**Replacement of Judd Road Bridge Over Mill River****Addendum #2**

5/13/2025

**REPLACEMENT OF BRIDGE 04929
JUDD ROAD OVER MILL RIVER
ROADWAY PLAN**

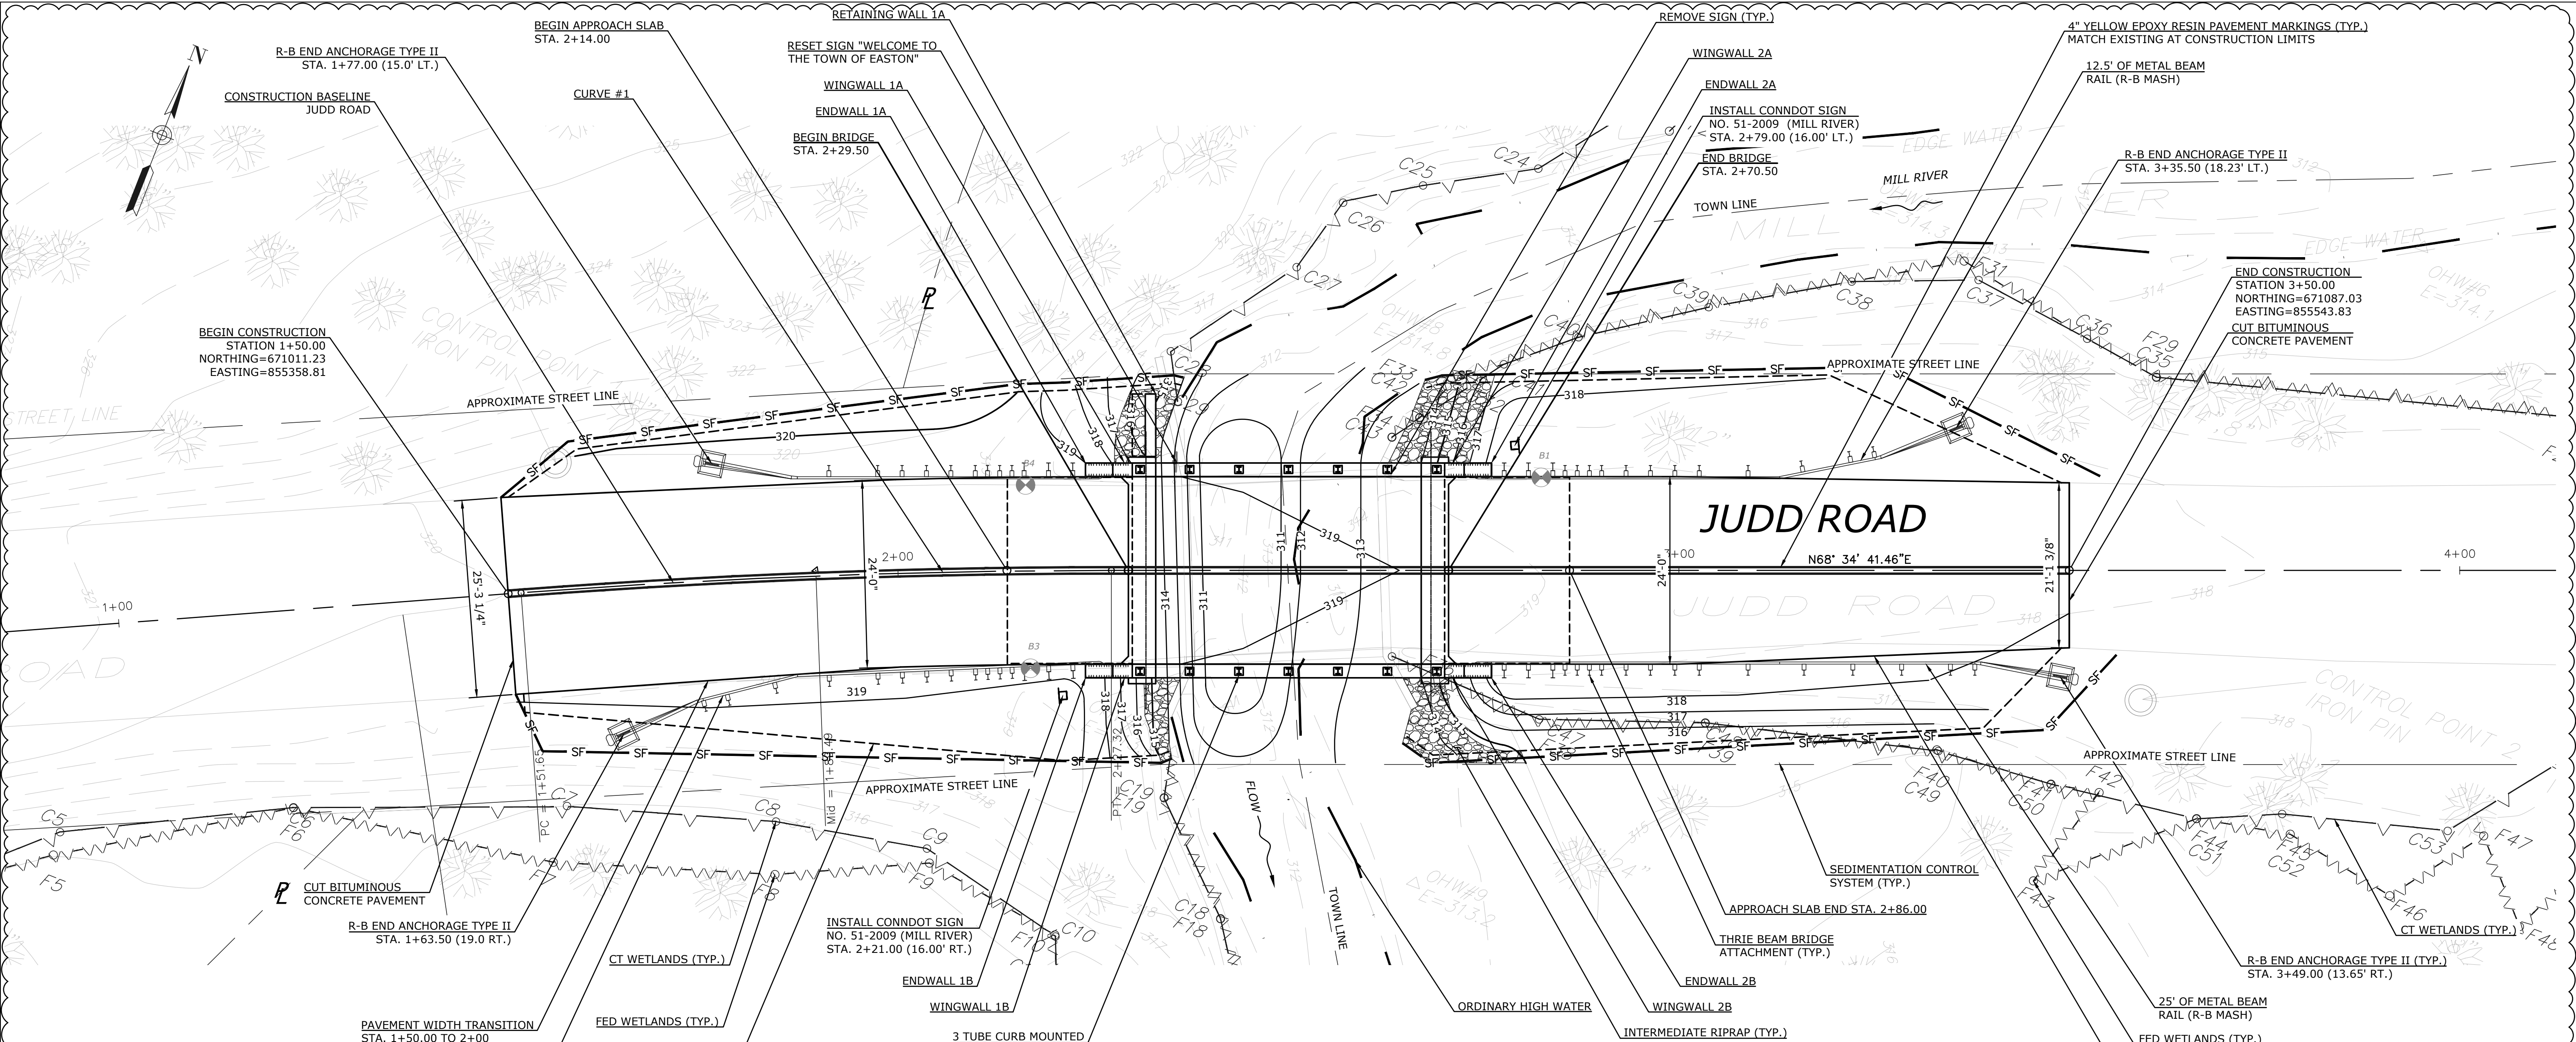
Q. Min Slope of Judd Road should be increased to promote water flow.

A. See revised plan sets to indicate a 1% road slope.
